# BODE RAINIER BEACH

RECOMMENDATION DESIGN GUIDANCE MEETING

PROJECT NUMBER: 3038509-LU

PROJECT ADDRESS: 9367 RAINIER AVE S, SEATTLE, WA 98118

**EDG SCHEME**

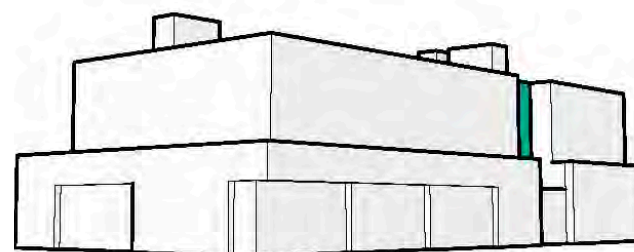
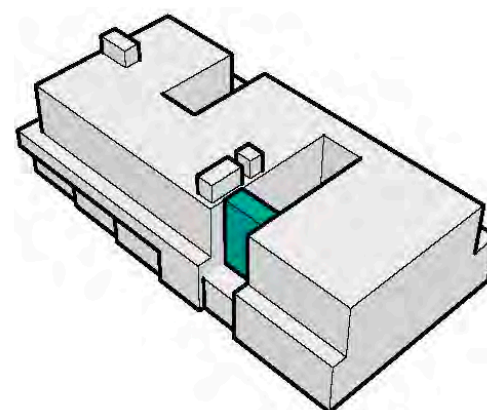
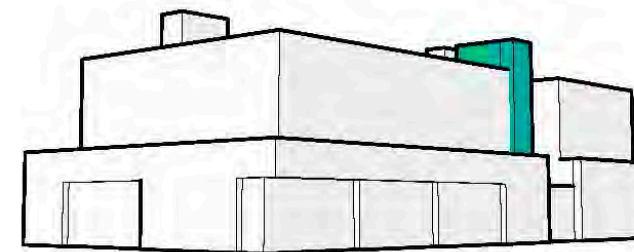
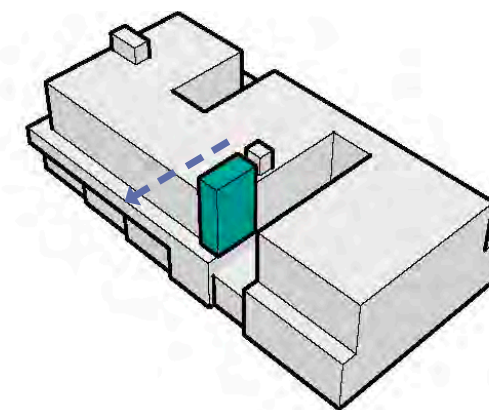
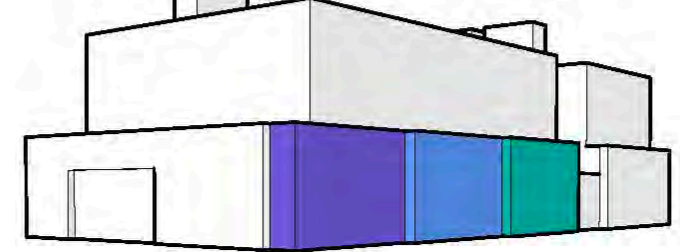
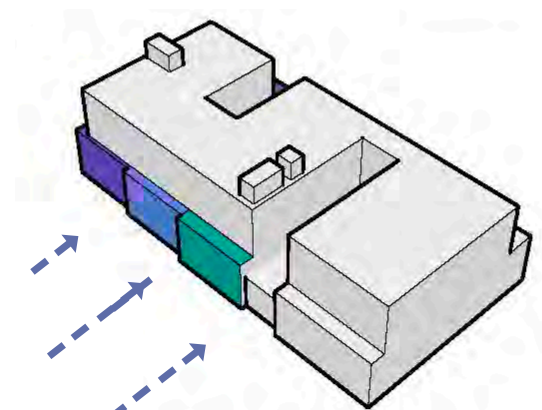
The Board agreed that the new preferred massing Option D was overall successful and supported this option as the basis for further refinement. The Board agreed that the new Option D appropriately balances the need for modulation along both the Rainier Ave and south facades, providing courtyards along each.

- The design has been elevated to the next phase with a team of consultants while still maintaining its identity as proposed at EDG 2.
- The project's preferred massing option D will create north and south-facing open spaces that will play a role in shaping a visual and physical break in the facade and bringing in sufficient sunlight into the courtyard.
- The massing has been developed around framing multiple shared and private outdoor amenities that have evolved to further strengthen the courtyard's access to sunlight, air, and usability of the outdoor amenities.

**1) BRIDGE ADDITION**  
A "bridge" was added as usable direct accessible route from each side of the building.

**2) RAINIER STAIR SCALE & PROMINENCE**  
The stair tower mass has greatly increased in scale and prominence and no longer reads as part of the residential units.

**3) NORTH EAST "SAWTOOTH" SETBACK**  
Reduce the number of the "sawtooth" setback moves at the live-work units. Removed upper level overhang as required for the overhead power lines.

EDG 2 NORTH - EAST SETBACK

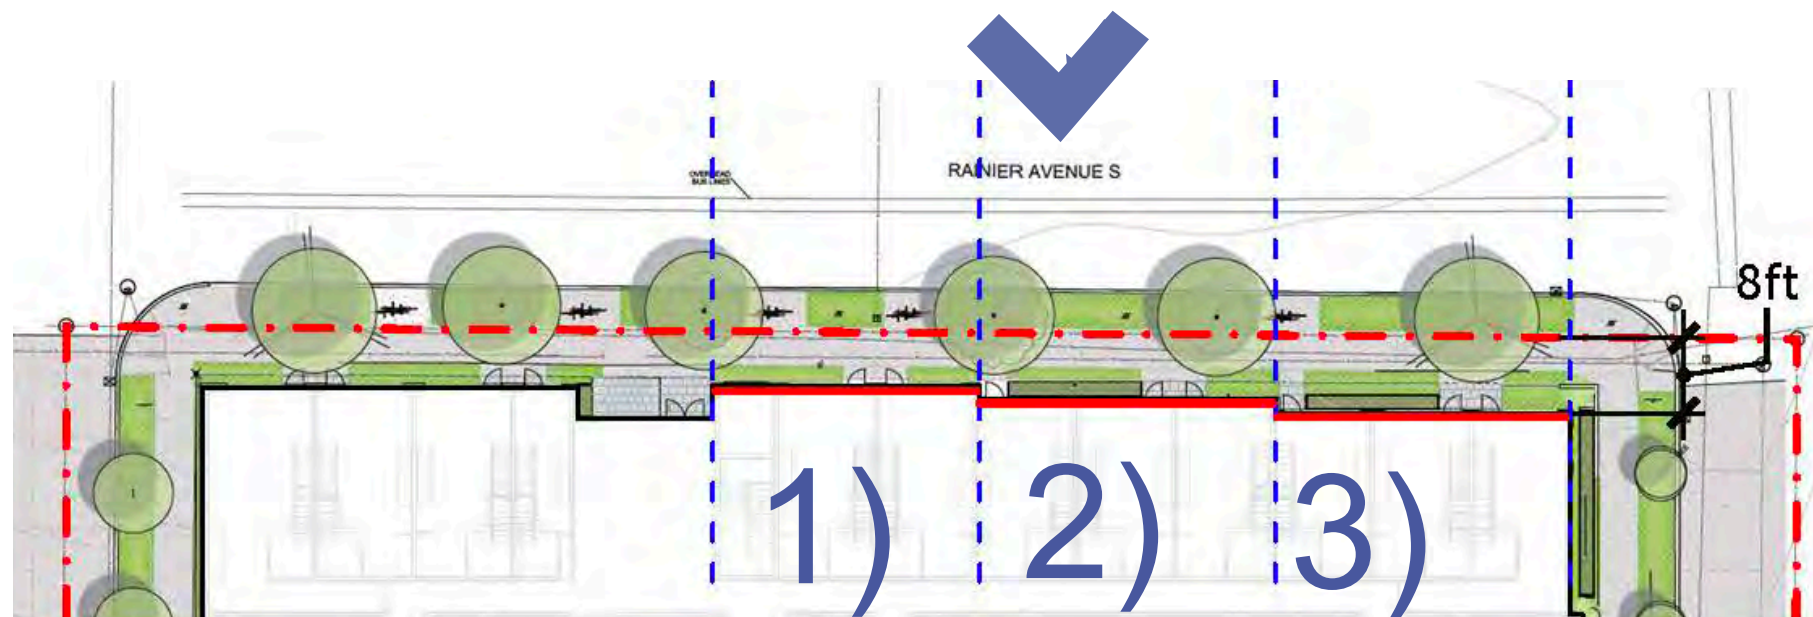
The Board discussed the “sawtooth” setback at the live-work units at the northeast and the cantilever of the third level above. While one Board member was concerned with this condition, the majority supported this massing response as an appropriate solution to the previous guidance. The Board appreciated the interesting modulation which provides a wider setback from the street and mitigates the monolithic street presence while holding the corner.

The northeast setback concept proposed at EDG 2 has been maintained and further developed. While reducing the number of the massing moves from 4 to 3, the “sawtooth” articulation has been thoughtfully simplified to identify the corner and strengthen the massing. The proposed 4th, 5th and 6th floors have been modified to increase the setback from overhead power lines establishing the facade planes in a clearer, distinct massing. The massing expression has been further enhanced with material and color treatments to compliment the design moves.

PERSPECTIVE: SOUTH EAST CORNER

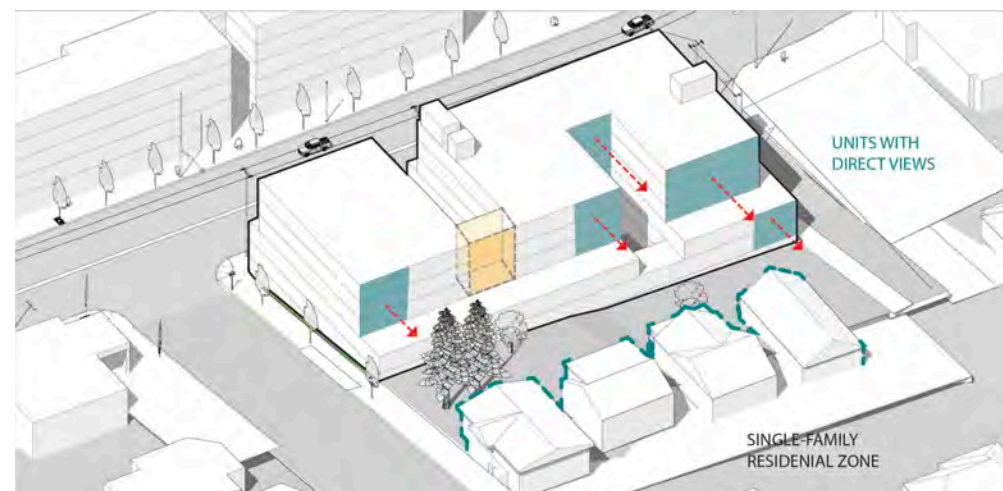
The Board supported the applicant's intent to differentiate the "gasket" at the west courtyard with transparency or a different material treatment. The Board noted they would also be supportive of subtle modulation at this facade element. The Board agreed that the material treatment and overall composition of the south elevation is highly important to providing a sensitive response at the zone transition and breaking down the bulk of the long facade, particularly at the circulation corridors.

The design has maintained the "gasket" treatment at the west courtyard. To improve the facade articulation and increase the amount of fenestration we incorporated an additional vertical massing recess that will be treated similar to the first "gasket". The two vertical massing recesses break the perceived building mass into 3 strong visual elements providing depth and interest to the south facade.

PERSPECTIVE: NORTH WEST CORNER

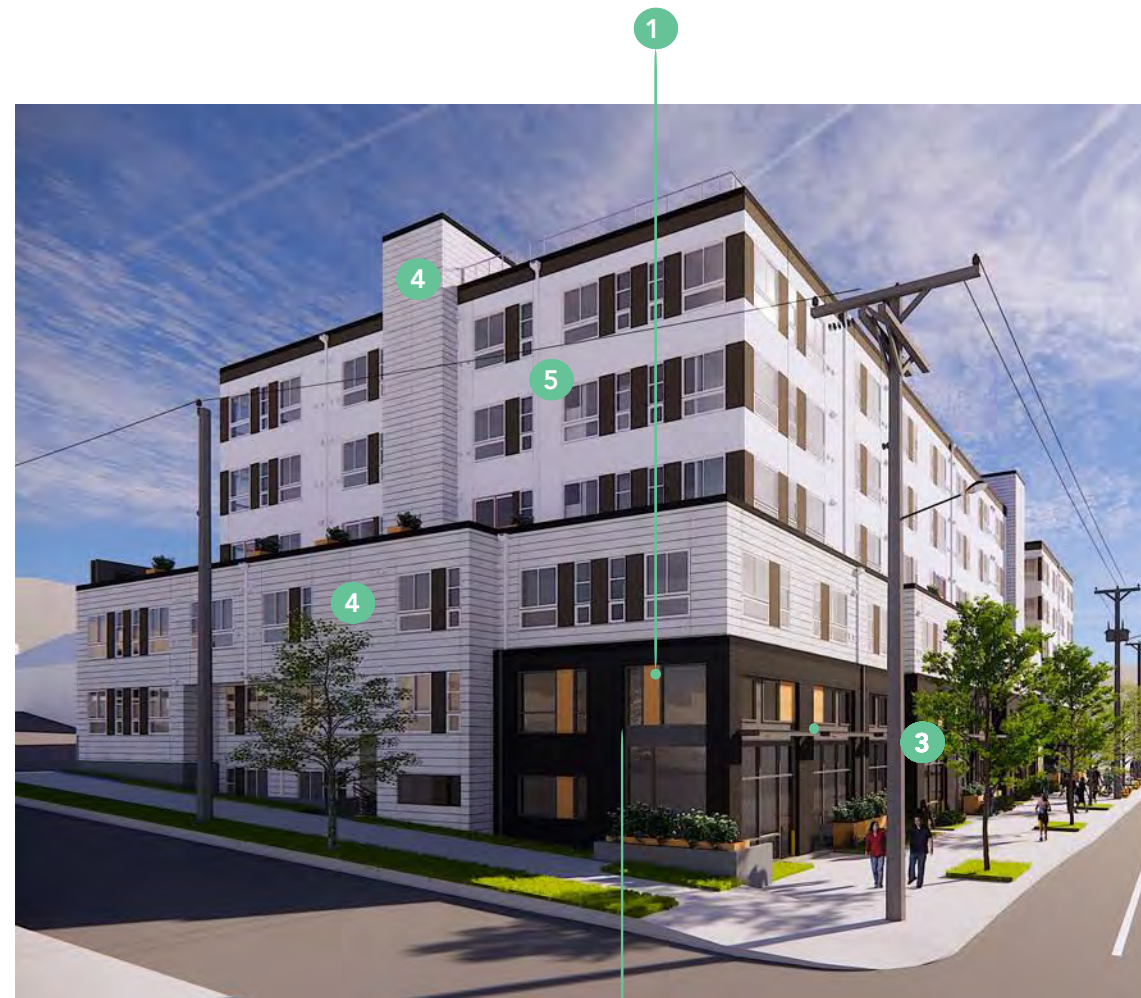
The Board agreed that the application of materials and detailing at the northeast corner differentiating stepping live/work units would be important to the success of this massing move.  
(DC2-B Architectural and Facade Composition)

The stepped massing facing Rainier was maintained and further refined to simplify the massing moves. The lowered mass wraps the corner with reduced "sawtooth" setback moves at the live-work units, while the cantilever of the third level above has been removed.
